PARTS & SERVICE NEWS

REF NO.	AT00089B
DATE	Jun. 27, 2001
(C)	Page 1 of 15

SUBJECT: REPAIR PROCEDURE FOR T/M FILL SWITCH ON DUMP TRUCKS AND BULLDOZERS

PURPOSE: To introduce repair procedures for the fill switch of the ECMV for the transmission on dump trucks and bulldozers

Fig. 1-1

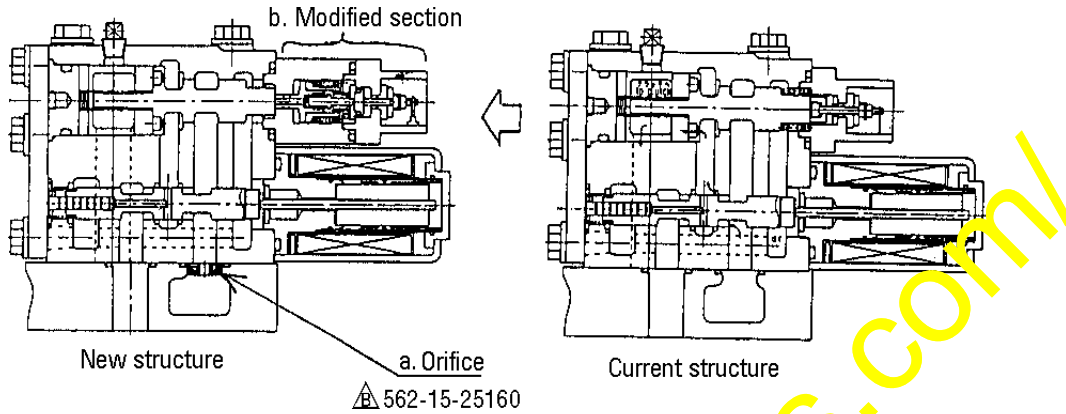
- a) An orifice has been supplemented for the purpose of suppressing the peak pressure occurring when the filling is completed. (Refer to Fig. 1-1.)

Fig. 1-2

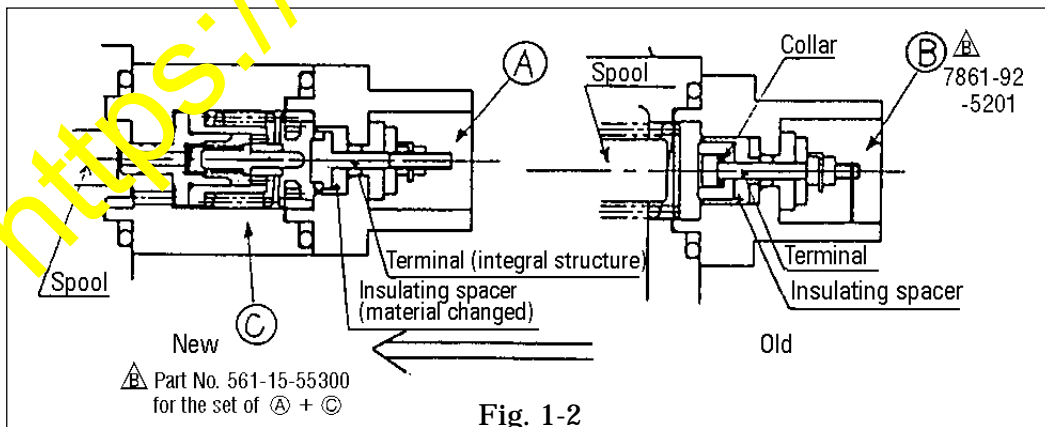
- b) The operation structure of the low clutch fill switch has been changed. (See Fig. 1-2).
- c) The reliability in electrical continuity of the fill switch has been improved. Changes of fill switch
 - c-1) The terminal has been modified into an integral structure to improve the reliability in electrical continuity.

New ←	Old
Terminal structure	Terminal changed into an integral structure	Collar/terminal separate structure

- c-2) The insulating spacer material has been changed to cotton cloth, which provides excellent bondage with resin.

Impact load upon completion of filling is reduced by addition of the impact absorbing structure  .	←	Impact load upon completion of filling was applied directly from the spool to the collar.
---	---	---

Fig. 1-3

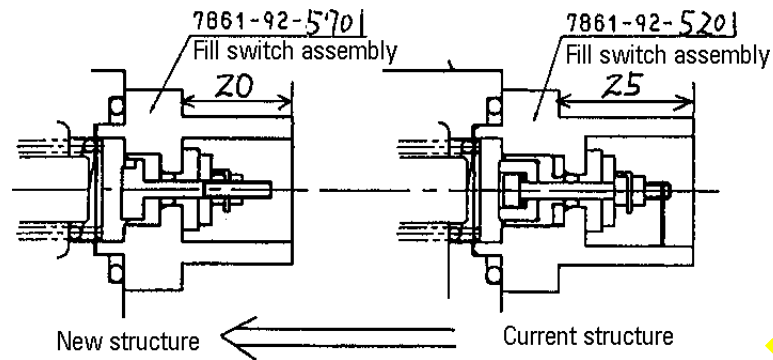
- 2) Changes of the ECMV assembly except for the low clutch (See Fig.1-3).
The fill switch has been changed to have an improved reliability in electrical continuity.

Fig. 2-2

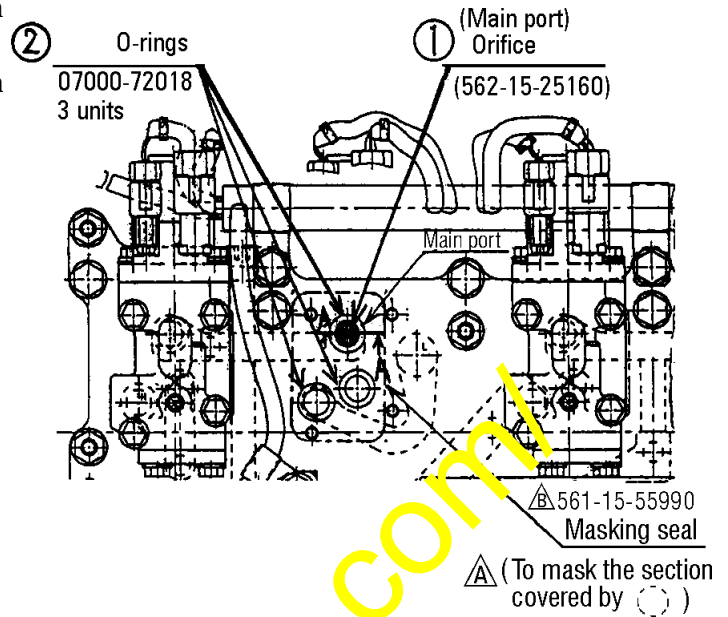
- c) Replace the three O-rings ② with new parts. (Refer to Fig. 2-2.)
- d) Install the orifice ① to the main port in the valve seat.

Refer to Fig. 2-2 regarding the installation location.
 Be careful not to install the orifice at a wrong place.

Fig. 9 (Ready-to-install state)

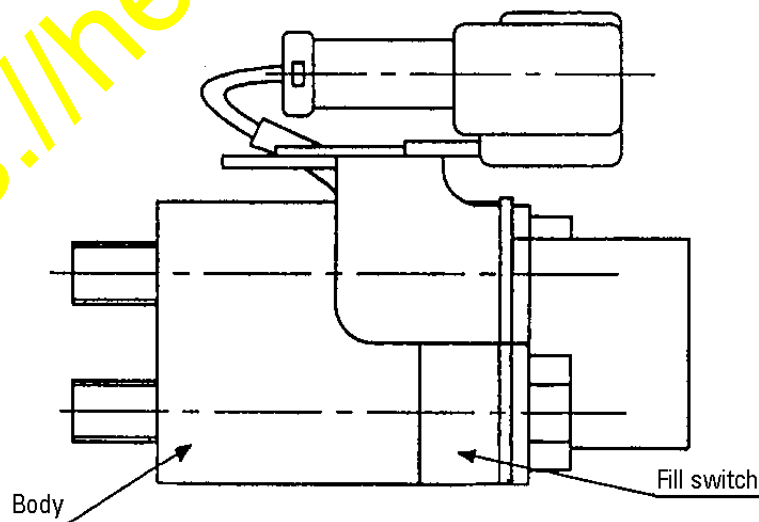
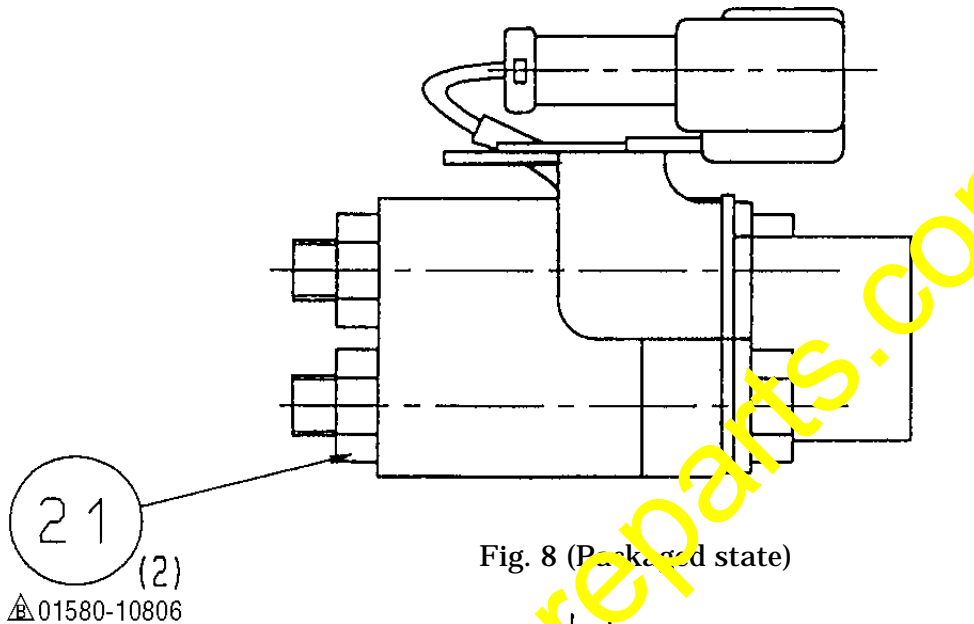
- b) Make preparations so that the replacement fill switch (part number 561-15-55300) can be mounted. Replacement parts are assembled as shown in Fig. 8. Nuts ② are jig parts to constitute the assembly, so remove them as shown in Fig. 9 before you mount the fill switch.

Note: It should be noted that the body and fill switch will come apart by the internal spring force when the nuts are removed.

Fig. 10

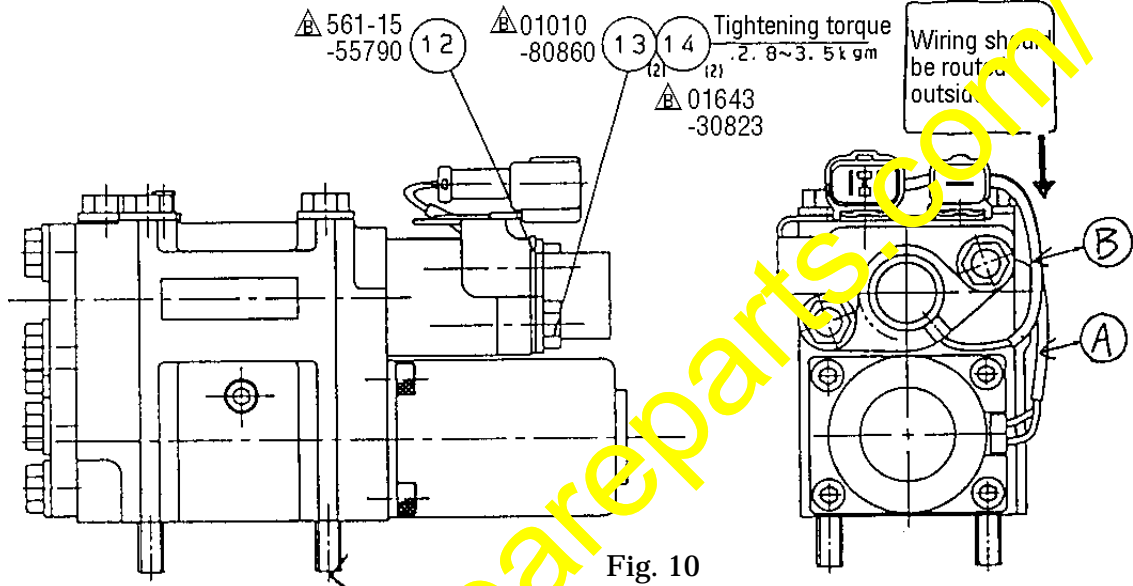
c) Mount the replacement fill switch (part number 561-15-55300).

(See Figs. 10, 11 and 12).

- Mount the fill switch (③ through ⑭).
- Mount a new O-ring (⑯).
- Tightening torque range of the mounting bolt (⑭) : 2.8 to 3.5 kgm.
- Solenoid wiring (A) and fill switch wiring (B) should be routed outside, as shown in Fig. 11.

Fig. 16

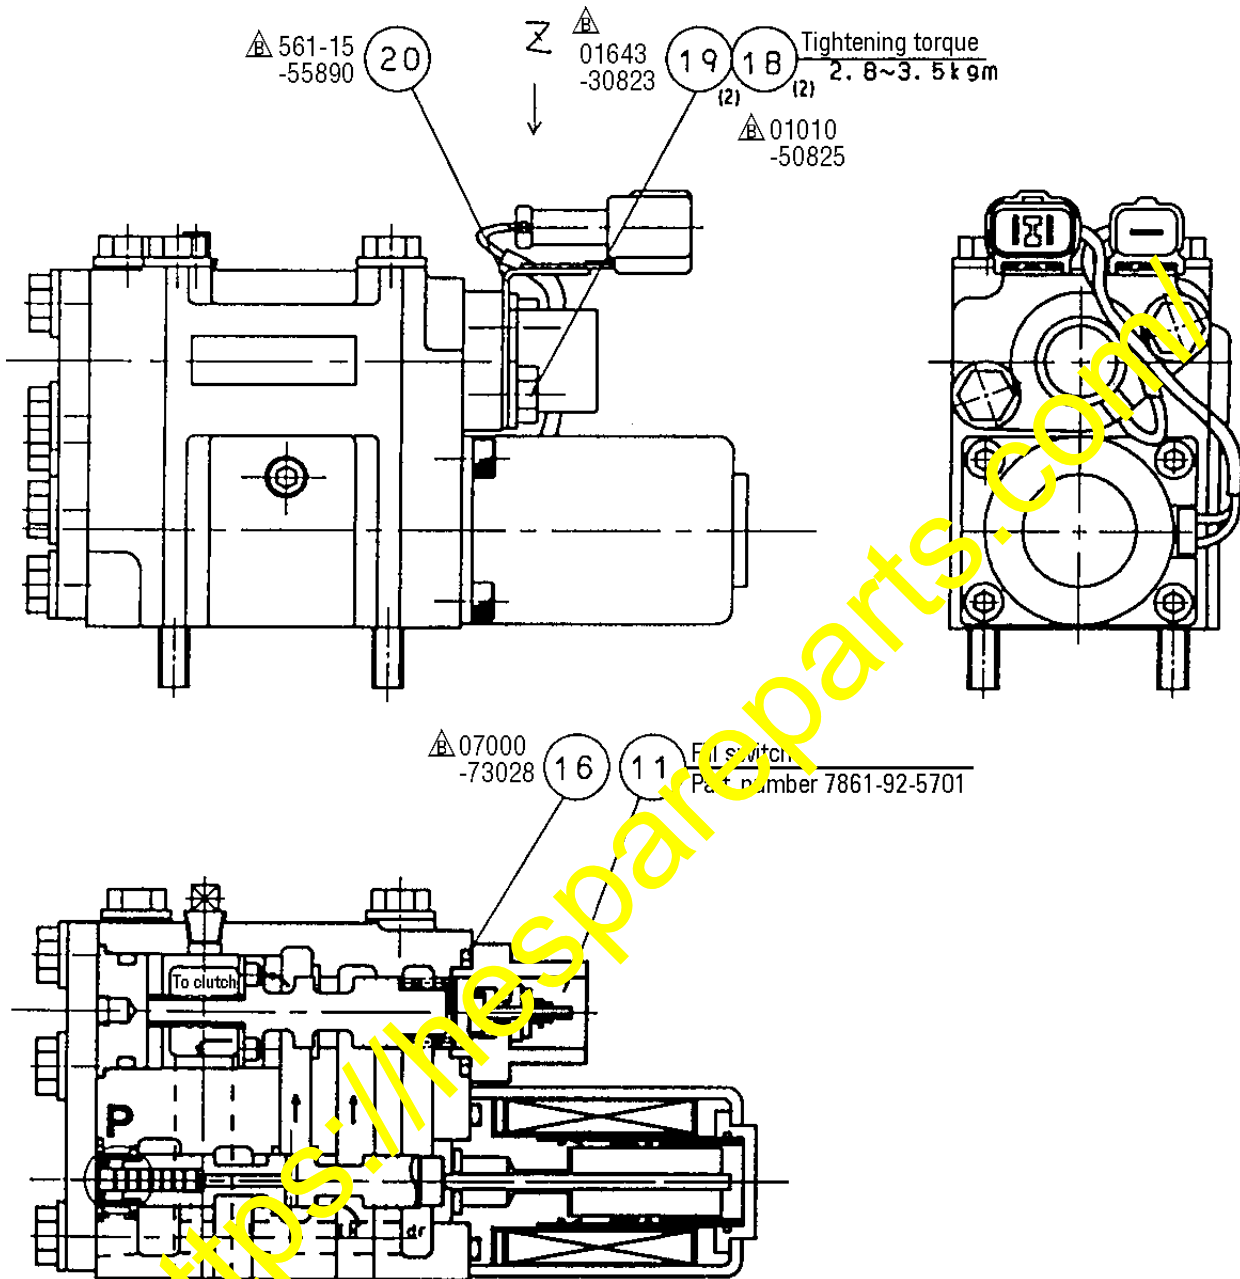
- b) Mount the replacement fill switch (part number 7861-92-5701). (See Fig. 16.)
- Mount a new O-ring $\textcircled{16}$.
 - Tightening torque range of the mounting bolt $\textcircled{19}$: 2.8 to 3.5 kgm.

Fig. 17 (View Z)

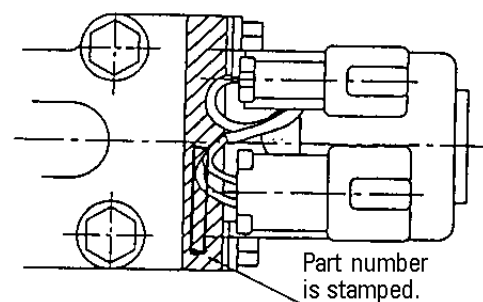
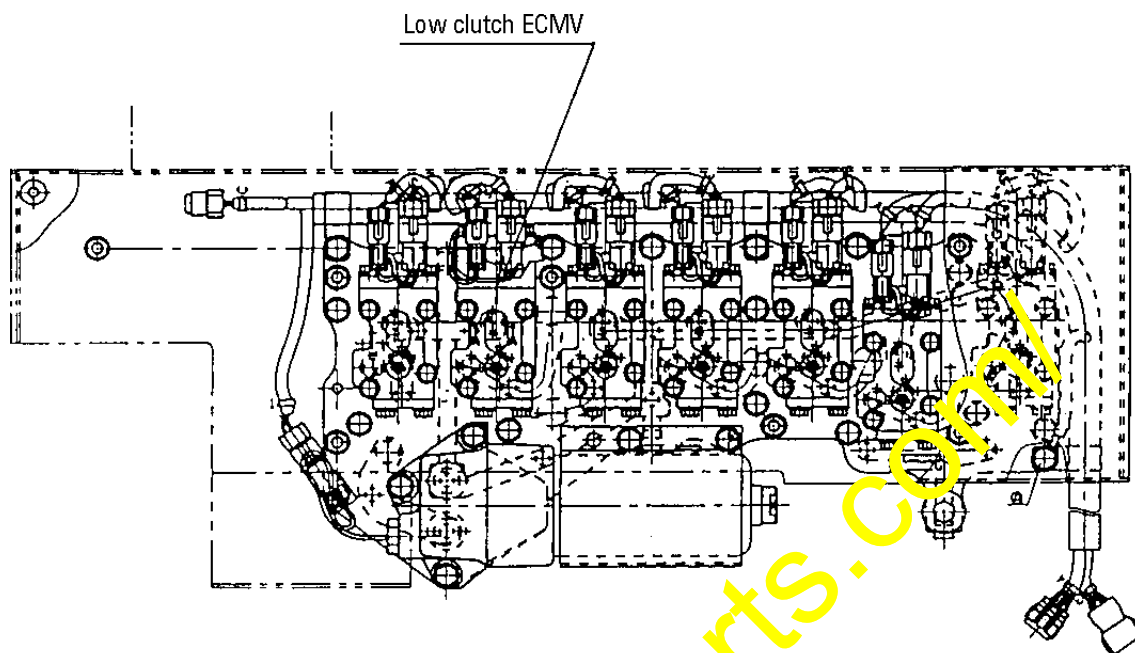
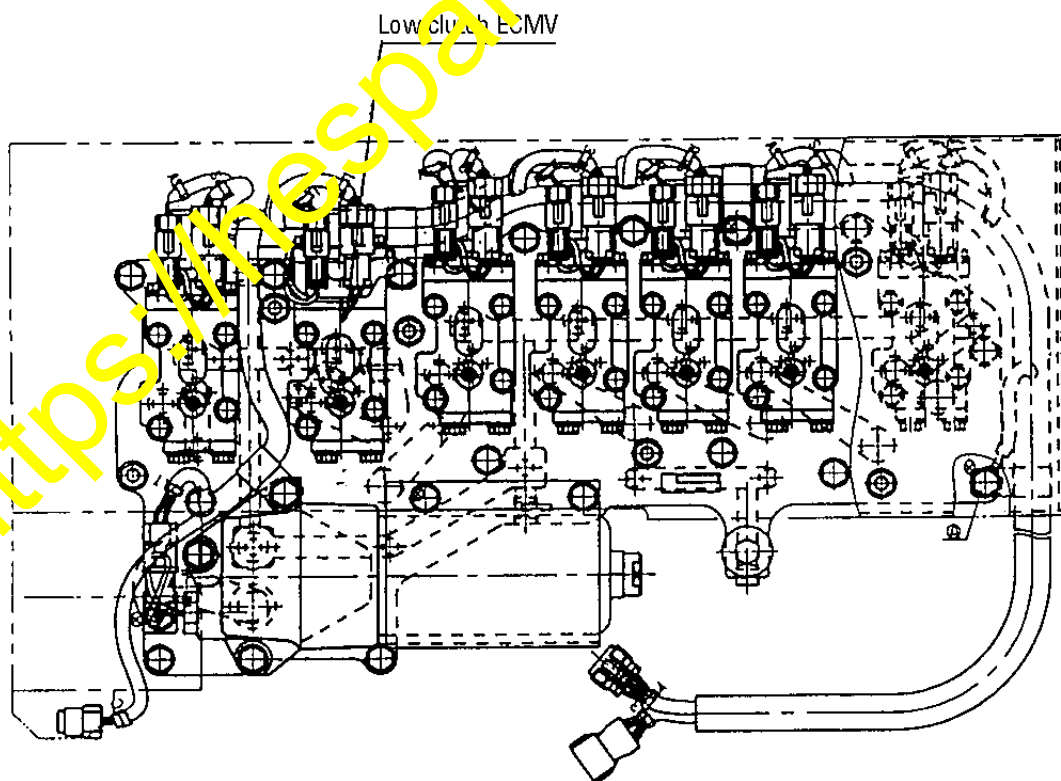
Part number 7861-92-5701 is stamped on the flange section (hatched section) of the fill switch as shown in Fig. 17.
